## Service Bulletin 2018-001

Issue Date: March 30, 2018

### **Subject: Upgrade reserve cover flap**

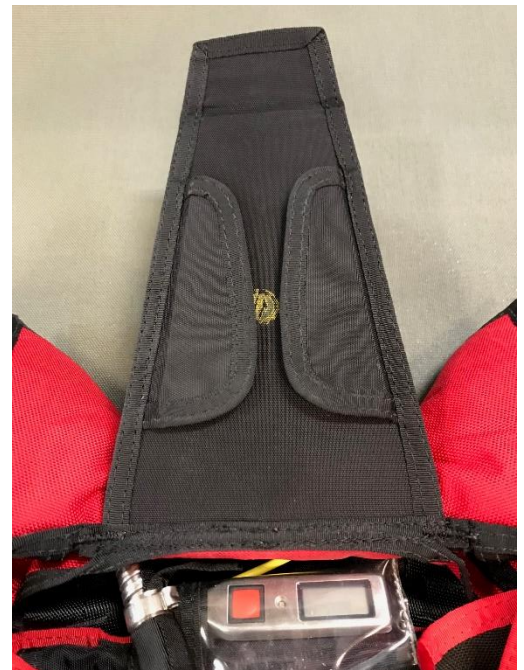
SIFE is offering an upgrade on the reserve cover flap.

We have been informed that during the annual reserve repack the reserve container opened with a delay of 0,18 seconds after pulling the reserve ripcord handle. The reserve cover flap wasn't moved or opened before the reserve ripcord handle was pulled.

The result of our investigations is that an increased friction between the reserve cover flap and the reserve container can lead to the unlikely event of a short delay of the opening of the reserve container.

1. Make sure that the reserve cover flap and the reserve container is clean before jumping.
2. Open the reserve cover flap to check your pin, the reserve loop and your Cypres before jumping.

We are offering an upgraded reserve cover flap free of charge to all our customers who own an affected container size.
